Federal Register

[Docket No. 2002-SW-14-AD; Amendment 39-13015; AD 2003-01-04]

Airworthiness Directives; Bell Helicopter Textron, Inc. Model 204B, 205A, 205A-1, 205B and 212 Helicopters

ACTION: Final rule; request for comments.

Figure 1. Inspection of Main Rotor Hub Grip Tangs

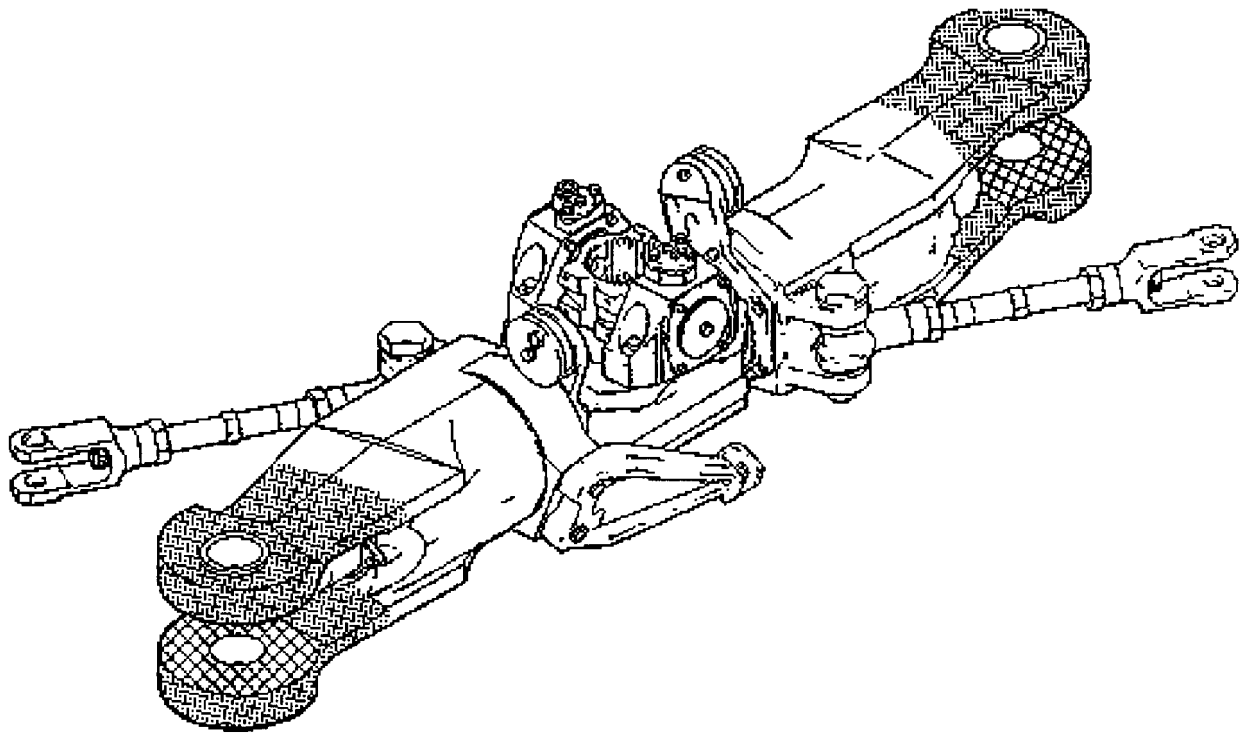
(2) Using a 10-power or higher magnifying glass, visually inspect the exposed surfaces of the upper and lower tangs of each grip for a crack. Pay particular attention to the lower surface of each lower grip tang from the main rotor blade bolt-bushing flange to the leading and trailing edge of each grip tang. See Figure 1 as follows:

INSPECT BUFFER PAD
FOR DELAMINATION (IF
INSTALLED)

AREA TO BE INSPECTED
UPPER AND LOWER
TANGS ALL EXPOSED
SURFACES

(2) Inspect each grip buffer pad on the inner surfaces of each grip tang for delamination (see Figure 1 of this AD). If there is any delamination, remove the buffer pad and inspect the grip surface for corrosion or other damage.
